REF #: ICI19-026

SUBJECT: SF583 – Campaign Released in Phases

May 2019
SF583A-C

Subject: Freightliner Cascadia Cab Shock Mounts

Fig. 13, Installation of Reinforcement Plate Fasteners

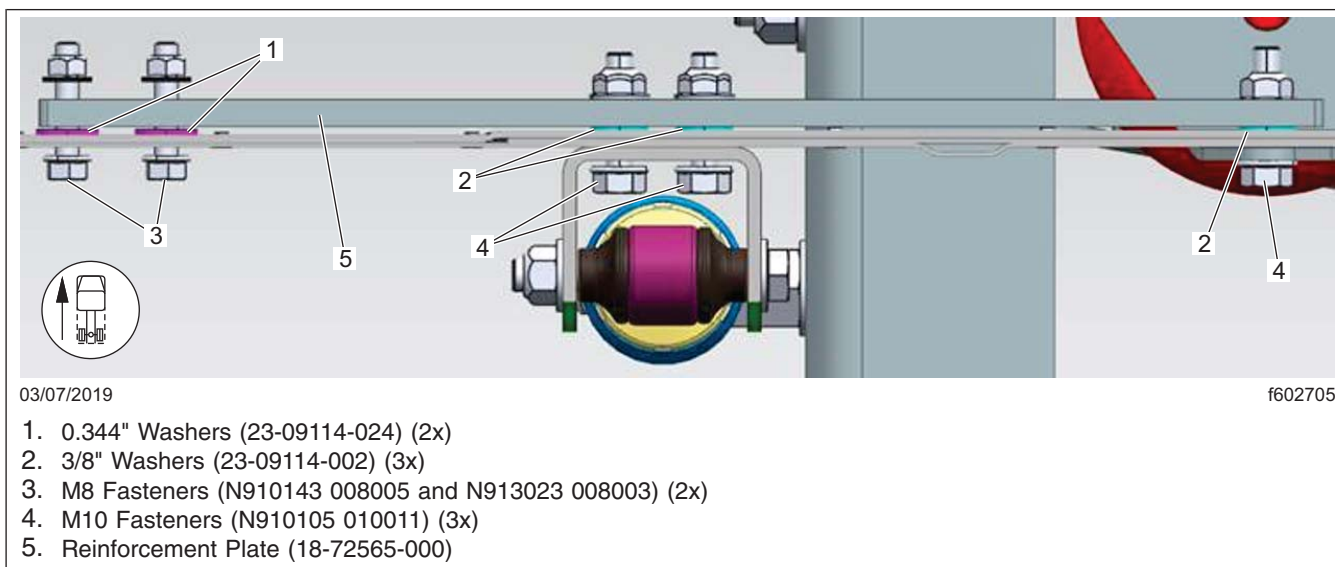
13. Fit the reinforcement plate, fasteners, and new height-control link bracket to the bottom of the back wall. Use the washers to space the reinforcement plate to clear the backs of the Henrob fasteners. See [Fig. 13](#) and [Fig. 14](#).

14. Tighten the fasteners on both reinforcement plates. Torque the M8 fasteners to 11 lbf·ft (15 N·m) and the M10 fasteners to 35 lbf·ft (47 N·m).

Fig. 15, Lateral Control Rod Bracket and Height-Control Valve

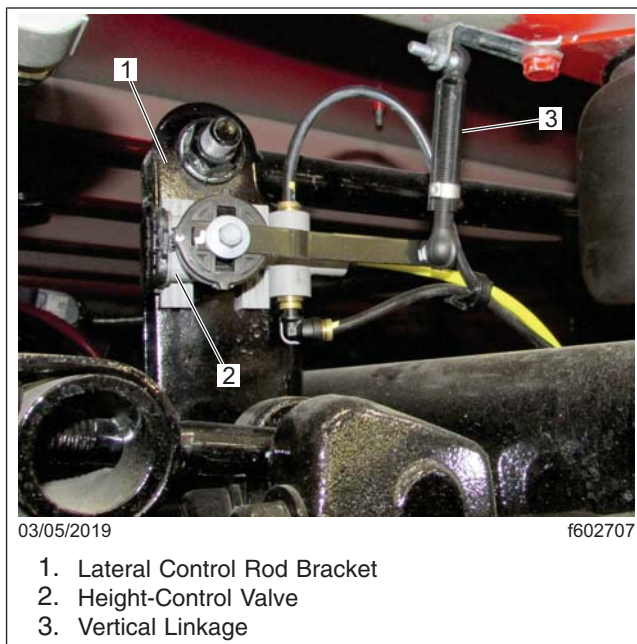
15. Remove the cab height-control valve from the lateral control rod bracket. See [Fig. 15](#).
16. Remove the vertical linkage mounting bracket from the cab. Retain the ball for use on the new bracket. See [Fig. 16](#). Install the bolt and torque to 35 lbf·ft (47 N·m).
17. Install the new height-control valve bracket on the lateral control rod bracket and torque the bolts to 46 ± 9 lbf·in (554 ± 1 N·cm). See [Fig. 17](#).
18. Install the height-control valve and torque the bolts to 46 ± 9 lbf·in (554 ± 1 N·cm). See [Fig. 17](#)

Fig. 18, Air Routing

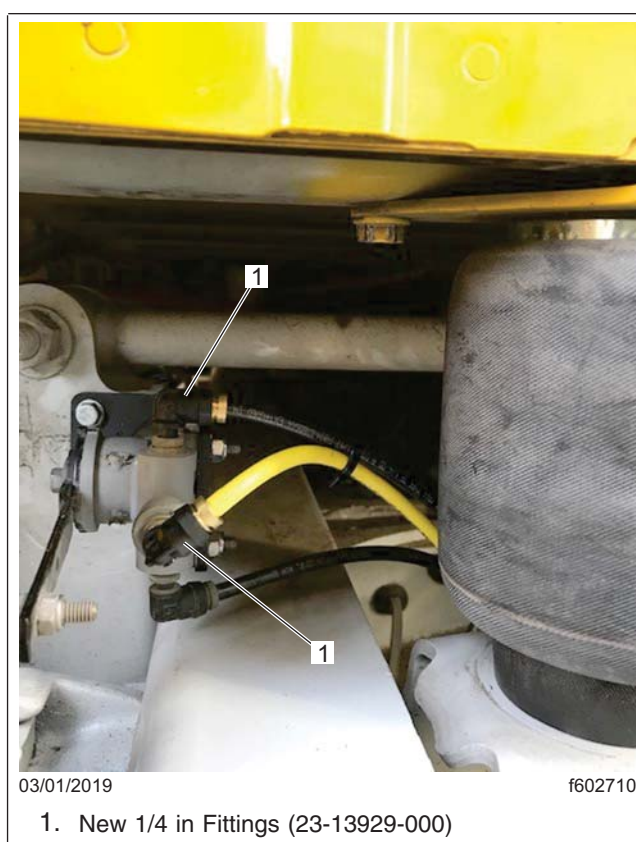
20. Install and secure the air line plumbing for the cab height-control valve, as show in **Fig. 18**.
- 20.1 Remove the supply and upper delivery air lines from the height-control valve.
- 20.2 Install new 90 degree fittings in the supply and upper delivery ports of the height-control valve. See **Fig. 18**.

- 20.3 Shorten the lines as needed to ensure they don't rub against moving or sharp parts. Be careful to maintain a bend radius large enough to prevent kinking and leaks at push-to-connect fittings.
21. Install the height-control linkage ball in the new bracket and tighten to 46 ± 9 lbf·in (554 ± 1 N·cm)
22. Start the engine and charge the air system.
23. Manually operate the height-control valve lever to inflate the cab springs then remove the cab support.
24. Install the new height-control vertical linkage (18-68769-040).
25. Install the shocks and torque the bolts to 40 ± 5 lbf·ft (54 ± 7 N·m).
26. Clean a spot on the base label (Form WAR259). Write the campaign number SF583 on a blank grey completion sticker (Form WAR261) and attach it to the base label to indicate the work has been completed.

Fig. 14, Installation of New Height-Control Link Bracket

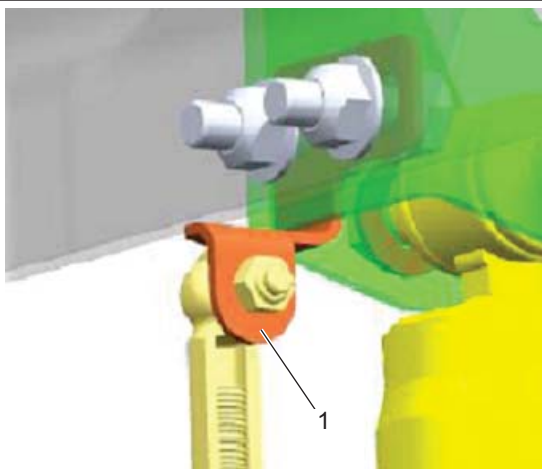
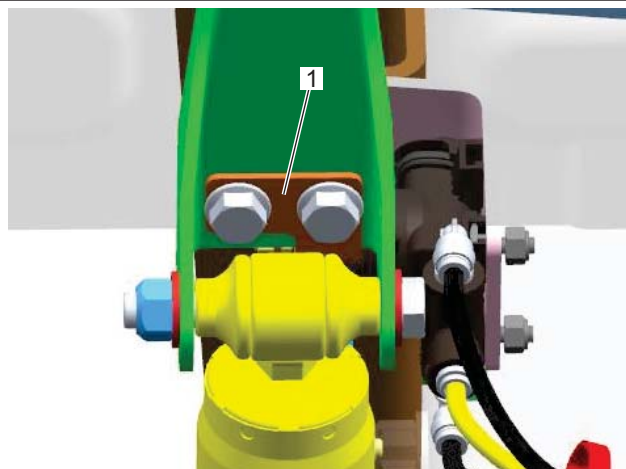
6. Deflate the cab suspension.
7. Remove the lower bolts from the shock brackets on both sides of the vehicle. Discard the bolts. See [Fig. 11](#).
8. Install the new height-control link bracket between the upper shock bracket and the lower bolt pair. Torque the fasteners to 35 lbf·ft (47 N·m). See [Fig. 14](#).

Fig. 15, Lateral Control Rod Bracket and Height-Control Valve

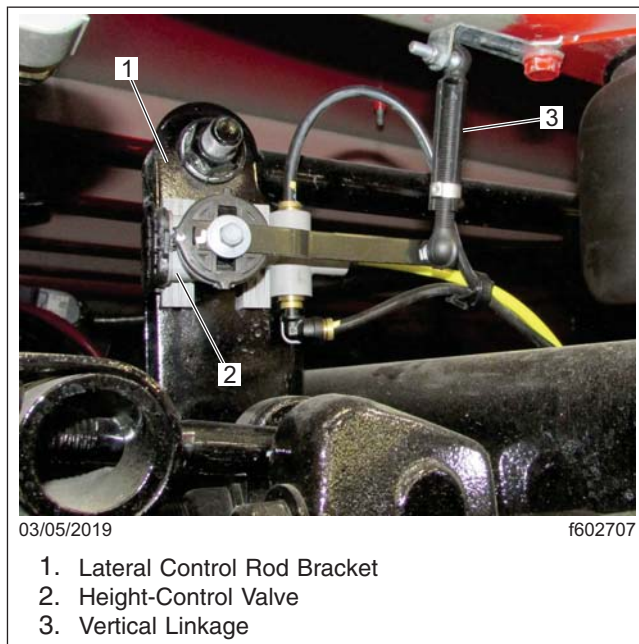
9. Remove the cab height-control valve from the lateral control rod bracket. See [Fig. 15](#).
10. Remove the vertical linkage mounting bracket from the cab. Retain the ball for use on the new bracket. See [Fig. 16](#). Install the bolt and torque to 35 lbf·ft (47 N·m).
11. Install the new height-control valve bracket on the lateral control rod bracket and torque the bolts to 46 ± 9 lbf·in (554 ± 1 N·cm). See [Fig. 17](#).
12. Install the height-control valve and torque the bolts to 46 ± 9 lbf·in (554 ± 1 N·cm). See [Fig. 17](#).
